QUAD CITIES NUCLEAR POWER STATION, UNIT 2

AMENDMENT TO FACILITY OPERATING LICENSE

Amendment No. 104
License No. DPR-30

ATTACHMENT TO LICENSE AMENDMENT NO. 104

FIGURE 2.1-3 (SCHEMATIC)

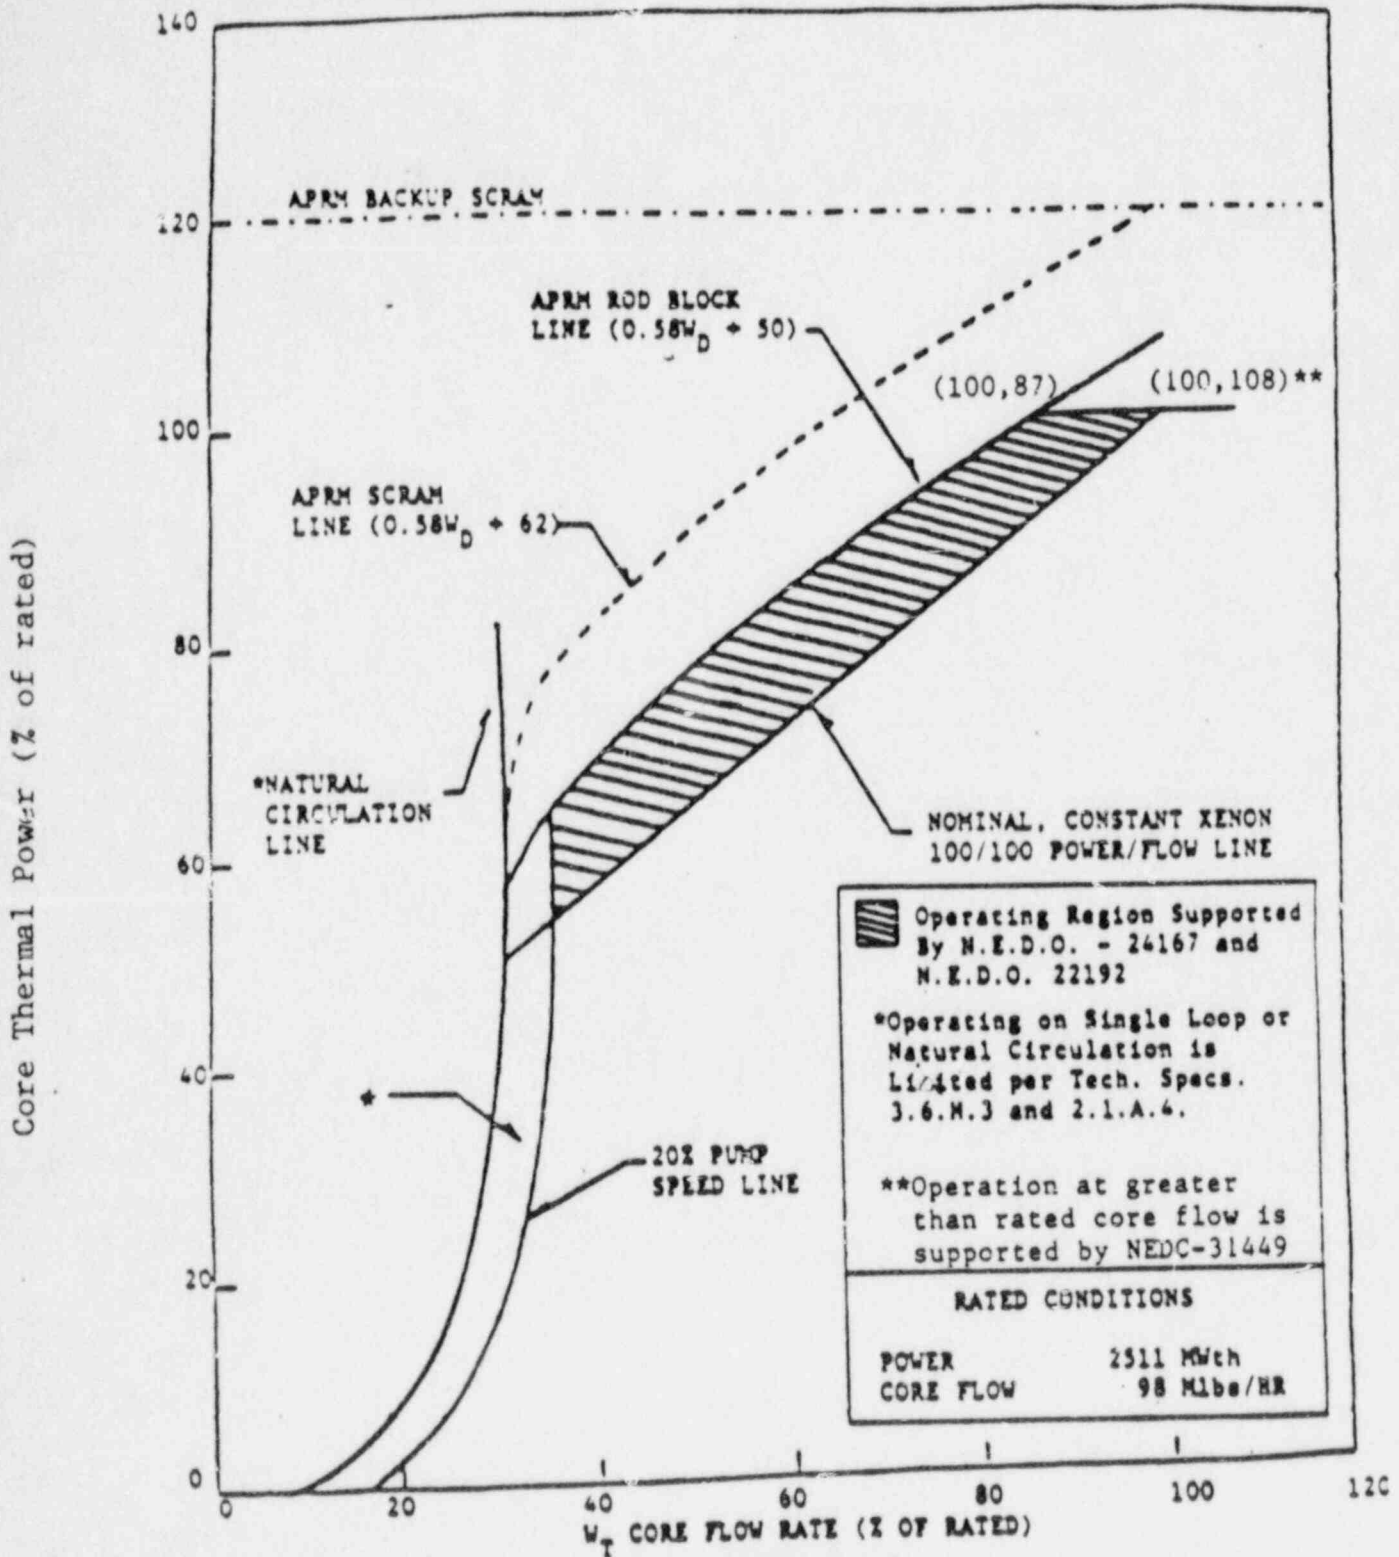
Figure 2.1-3

Figure 2.1-3

Amendment No. 104 APRM FLOW BIAS SCRAM RELATIONSHIP TO NORMAL OPERATING CONDITIONS

Figure 3.5-1
Sheet 5 of 5

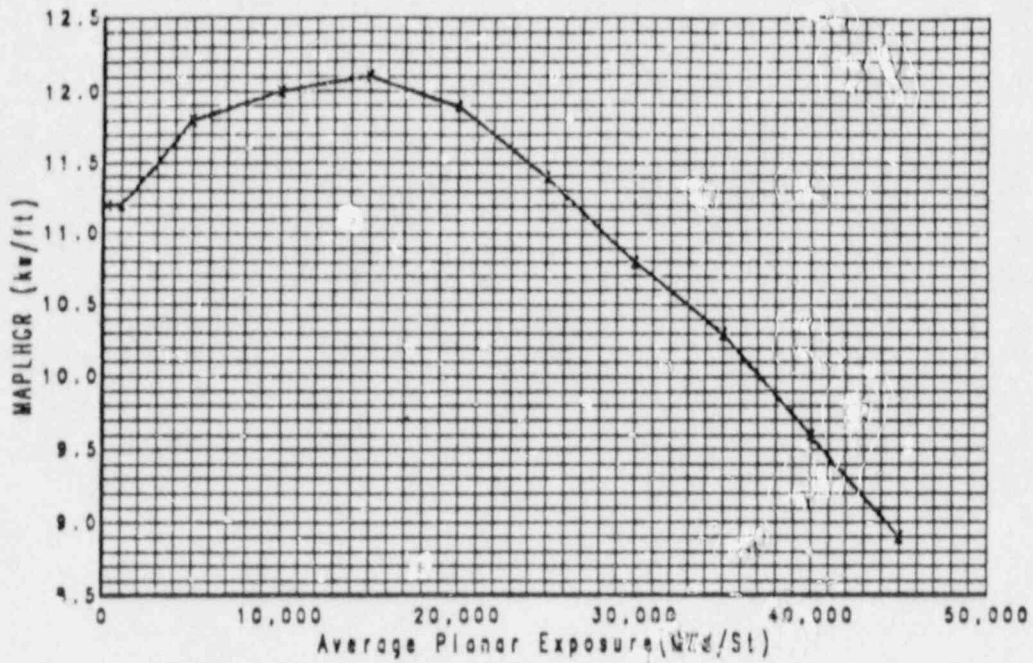
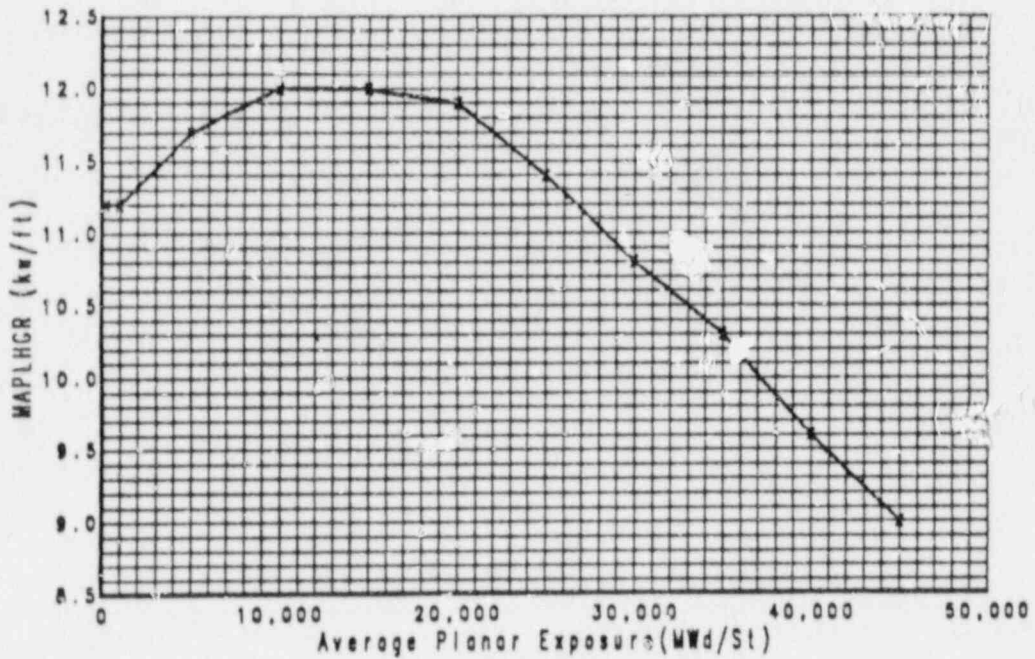
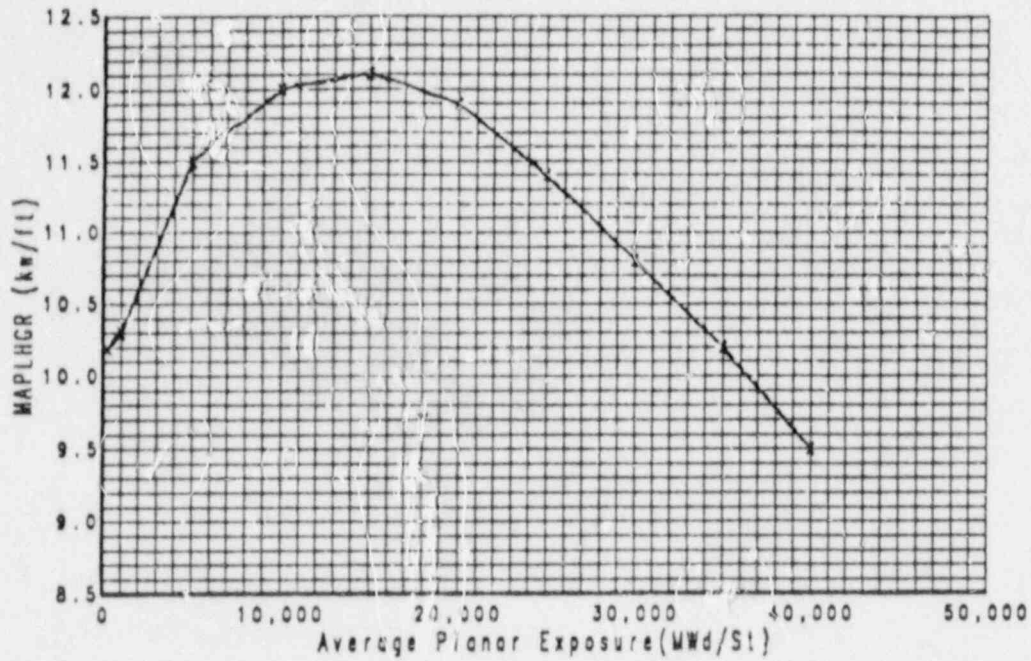
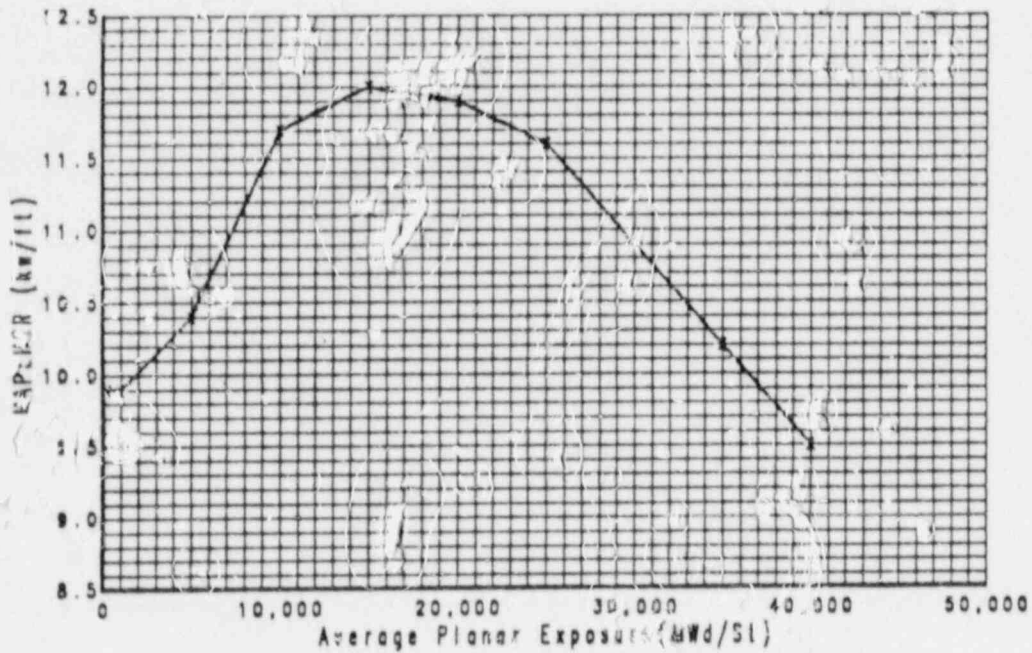
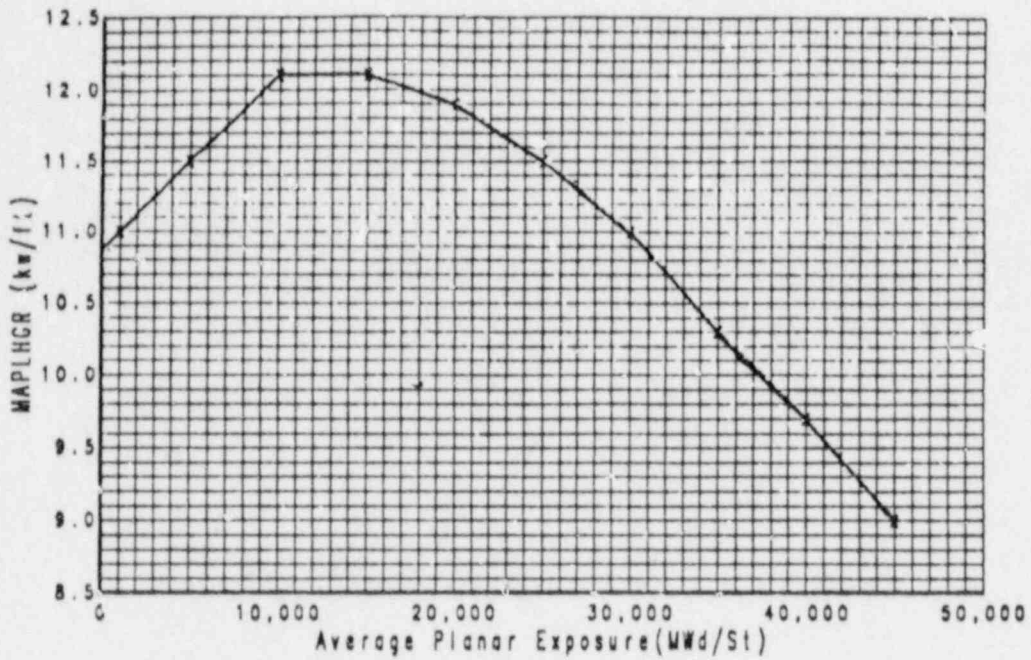
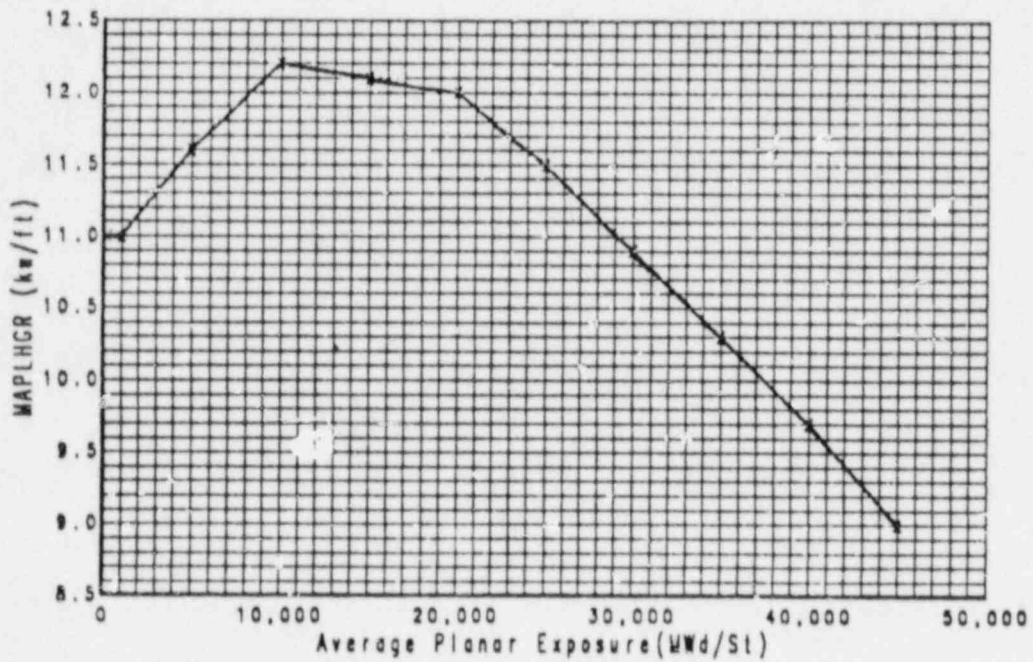
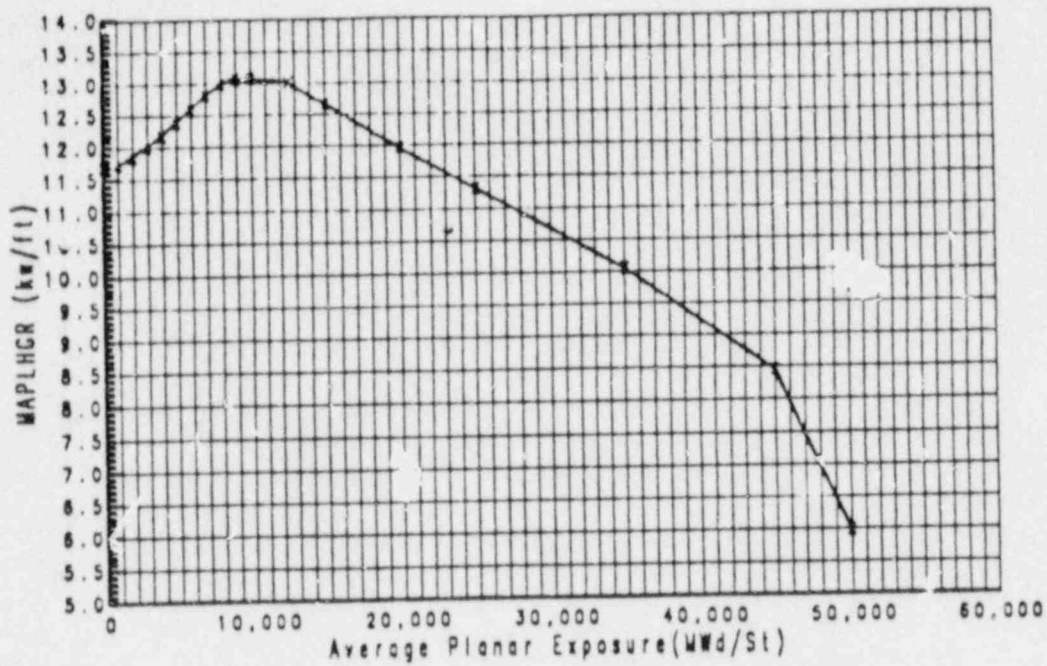
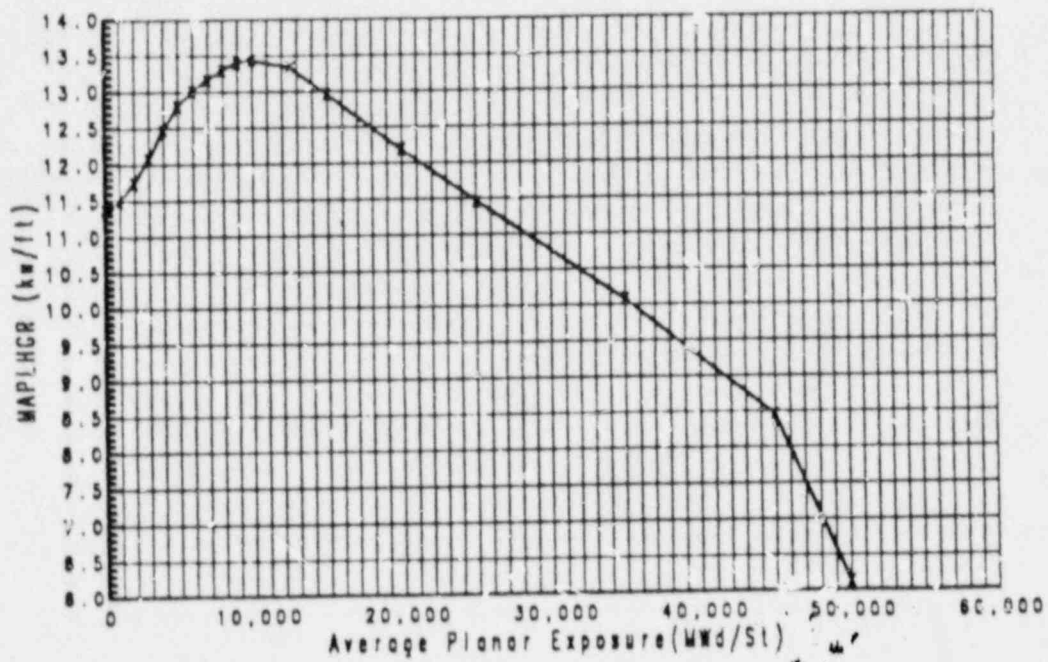
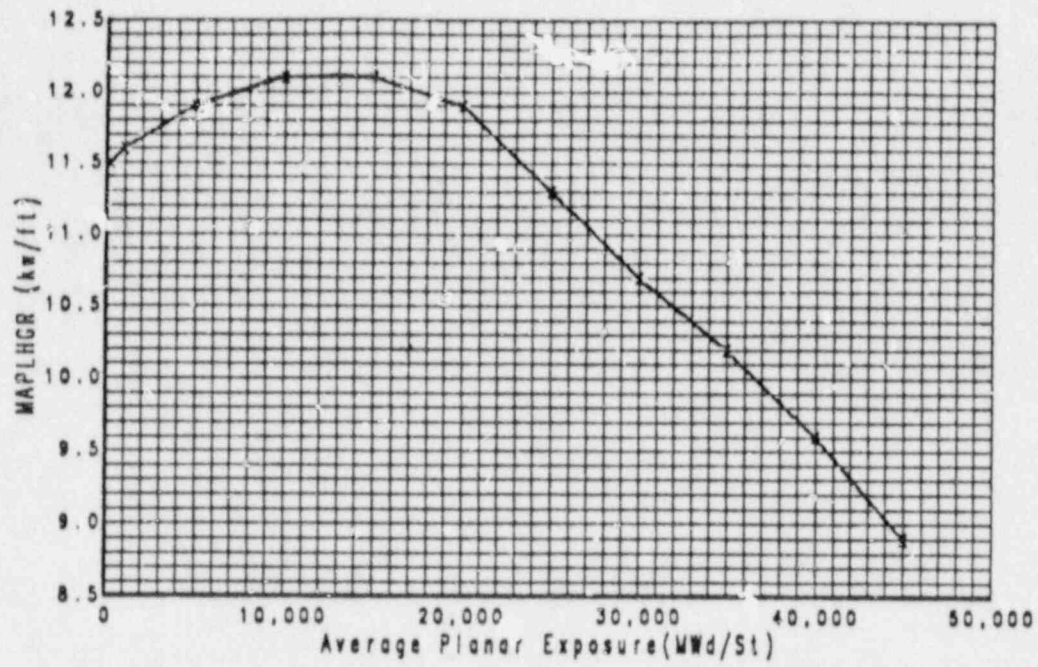
Figure 3.5-1 (Sheets 1 thru 6)

Figure 3.5-1 (Sheets 1 thru 5)

FIGURE 3.5-2

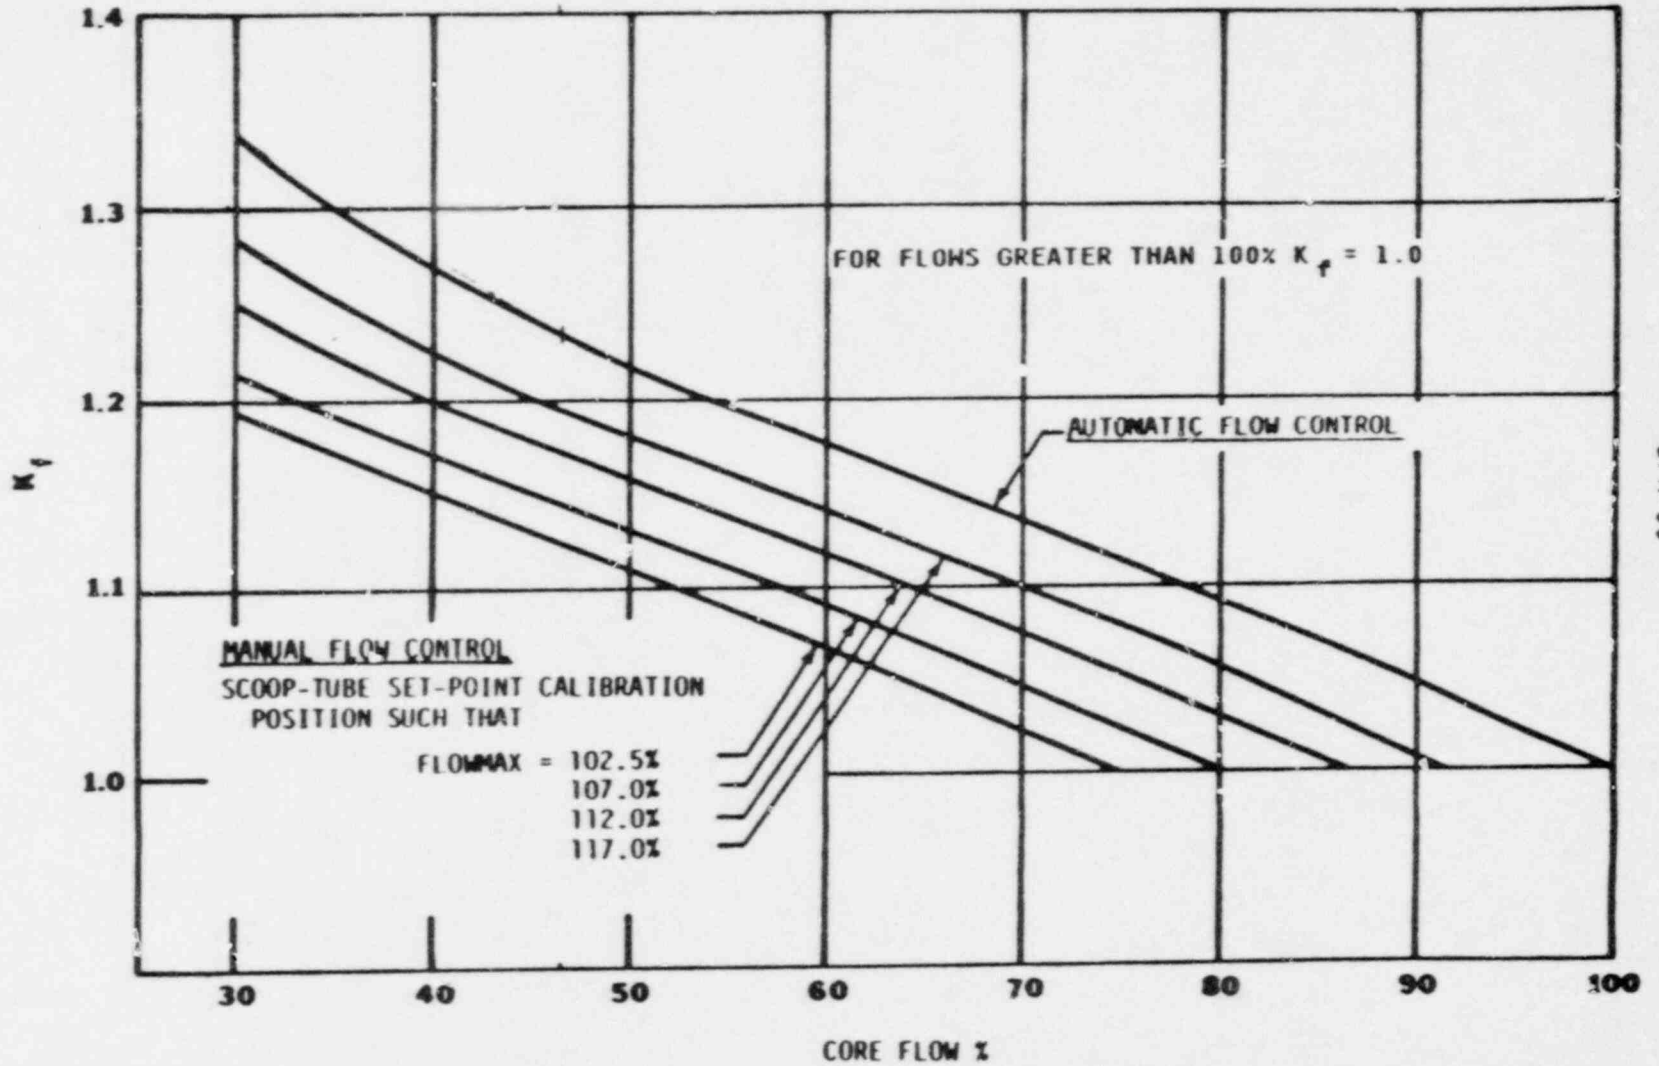
Figure 3.5-2

Figure 3.5-2

For core flows other than rated, these nominal values of MCPR shall be increased by a factor of k_f where k_f is as shown in Figure 3.5.2. If any time during operation it is determined by normal surveillance that the limiting value for MCPR is being exceeded, action shall be initiated within 15 minutes to restore operation to within the prescribed limits. If the steady-state MCPR is not returned to within the prescribed limits within 2 hours, the reactor shall be brought to the cold shutdown condition within 36 hours. Surveillance and corresponding action shall continue until reactor operation is within the prescribed limits.
